TUBE SHEET - PART "D" DE... HEAT CO...

THE WHITLOCK MFG. CO.
WEST HARTFORD, CONN.
TOTAL REQ'D TWO
JOB NO. 10N-[illegible]
DWG. B-25555-D REV. 1

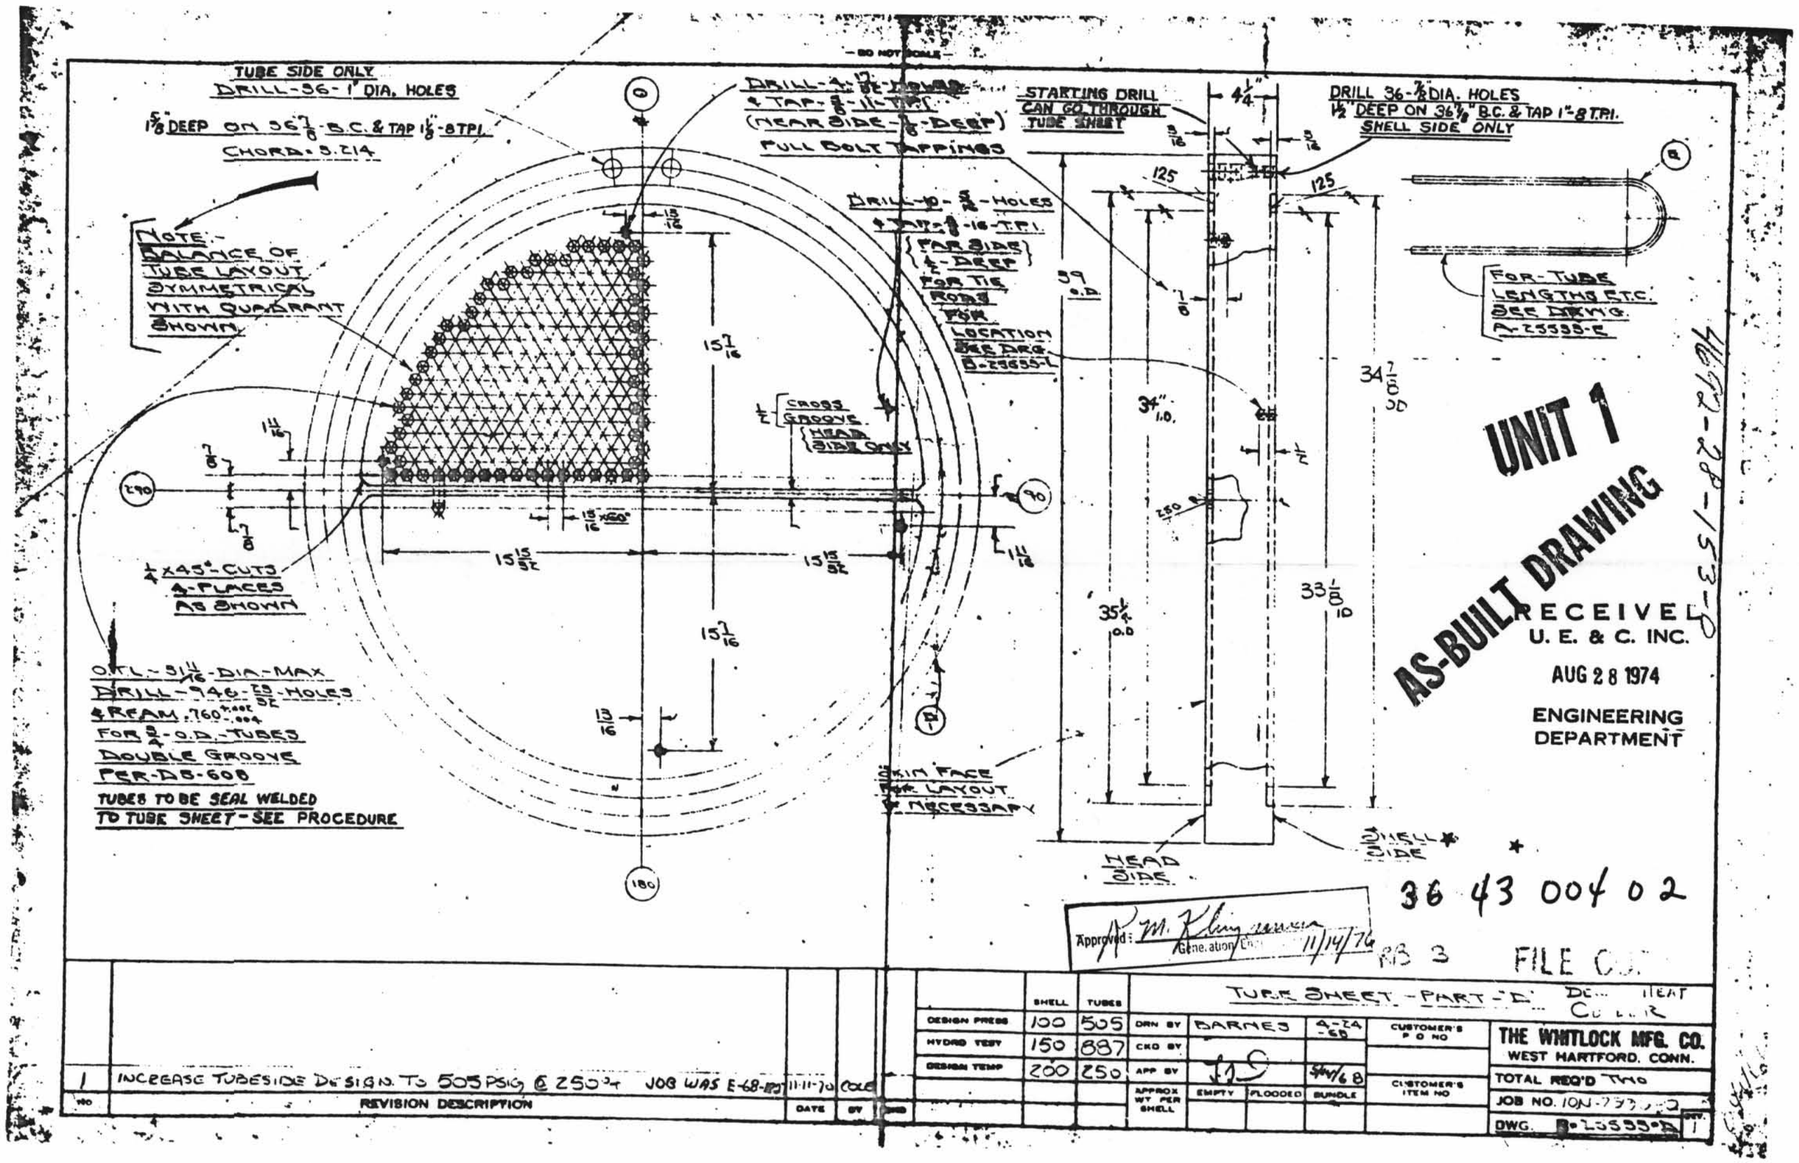
NO	REVISION DESCRIPTION	DATE	BY	CHKD
1	INCREASE TUBESIDE DESIGN TO 505 PSIG @ 250°F JOB WAS E-68-[illegible]	11-11-70	COLE

SHELL	TUBES
DESIGN PRESS	100	505
HYDRO TEST	150	887
DESIGN TEMP	200	250
